Subject: NHTSA Recall- 13V??? Rear Suspension Double Connecting Rod

Service Communication: 2013-002  **Recall-** Griso 8V / Norge8V / Stelvio NTX
Rear Suspension Double Connecting Rod

Affected Models: Select MY 2012-2013 Griso 8V
Select MY 2012-2013 Norge 8V
Select MY 2012-2013 Stelvio NTX

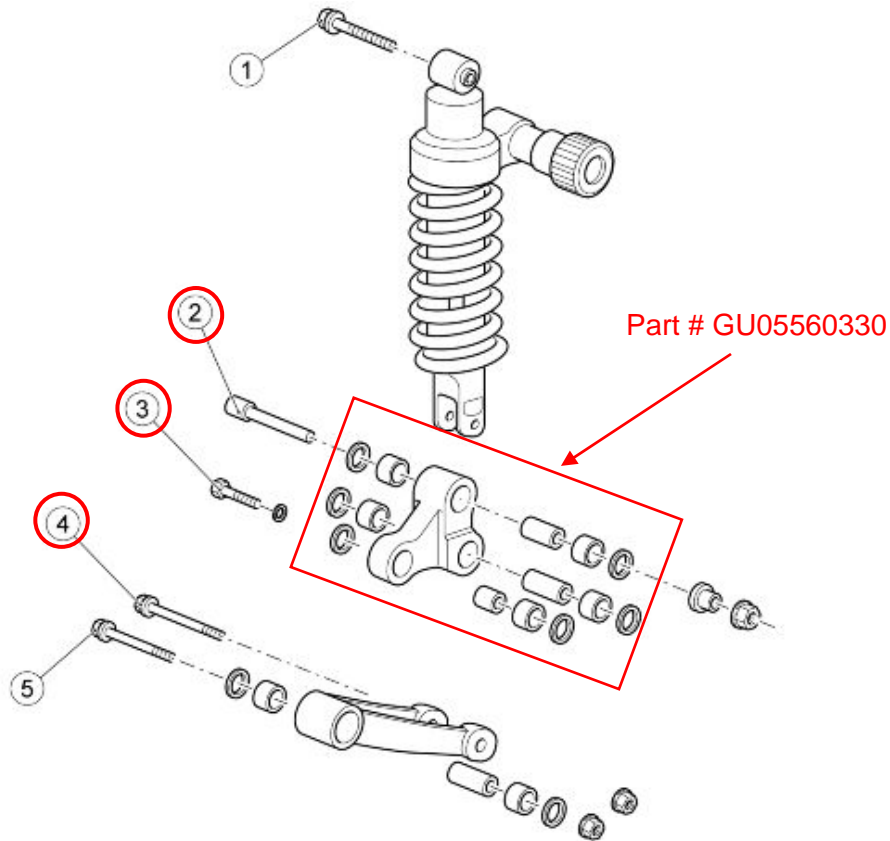
Concern: Based on continual product research and quality testing conducted by our technical department, we have found that a batch of rear suspension double connecting rods do not meet Moto Guzzi's quality standards. This connecting rod affects the vehicle's chassis and a failure of this component can jeopardize the stability of the motorcycle.

Cause: The rear suspension double connecting rods fitted to the affected vehicles do not meet quality standards

Correction: Replace the rear suspension double connecting rod

- Replace the rear suspension double connecting rod as shown in the workshop manual in the Chapter "Suspension - Shock absorber sect.", an extract of which is provided below.

| pos. | Description | Type | Qty | Torque |
|------|---|--------|-----|---------------------|
| 2 | TCEI screws for fixing double connecting rod/swingarm | M10x82 | 1 | 50 Nm (36.88 lb ft) |
| 3 | TE screw for fixing double connecting rod/shock absorber | M10x47 | 1 | 40 Nm (29.50 lb ft) |
| 4 | TE flang. screws for fixing single connecting rod/double connecting rod | M10x95 | 1 | 50 Nm (36.88 lb ft) |
